## MEMORANDUM

<b>DATE:</b>	February 12, 2021	<b>RWDI REFERENCE #:</b> 1904405
<b>TO:</b>	Anthony Witherdin	Director, Key Sites Assessments - DPIE
<b>FROM:</b>	Kevin Peddie	<b>Email:</b> kevin.peddie@rwdi.com
	Michael Pieterse	michael.pieterse@rwdi.com
<b>RE:</b>	<b>ADG Natural Cross Ventilation- City of Sydney Review Response Waterloo Metro Quarter - Building 2</b>

**Image 1c: Building 2 Proposed Floor Plan**

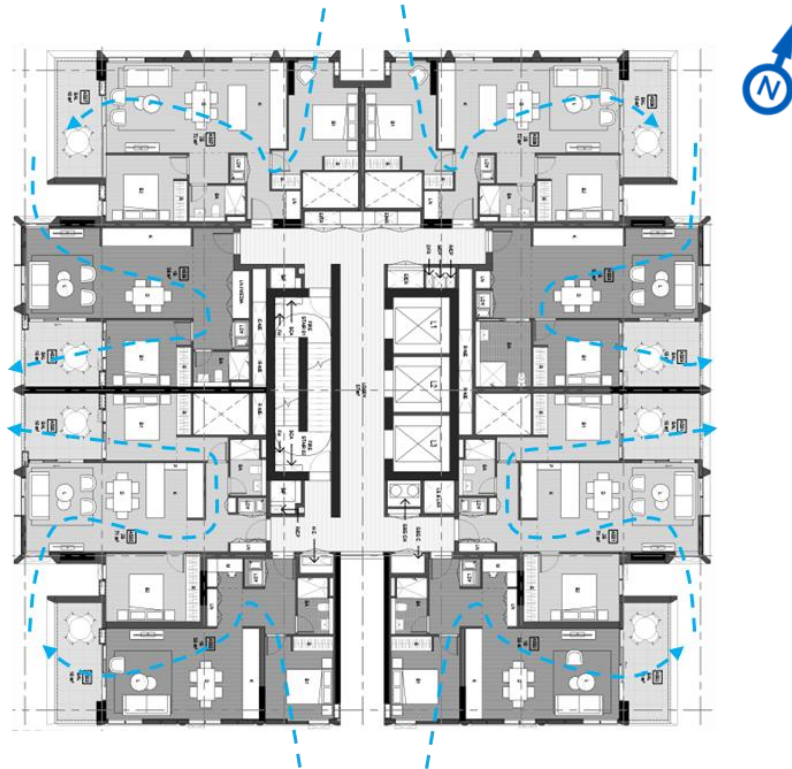
*Natural cross ventilation – Objective 4B-3 of the ADG recommends a minimum 60% of apartments to be naturally cross ventilated. The applicant includes centrally located apartments as achieving natural cross ventilation, notwithstanding these do not meet the definition under the ADG. Furthermore, at least half of the apartments that do meet the definition of natural cross ventilation are noise affected and will require windows and doors to be closed to comply with Objective 4J-1. As such the development provides well below the minimum recommended.*

The floor plate design of Building 2, also shown in Image 1c shows the alignment of the natural cross ventilation design with the ADG example.
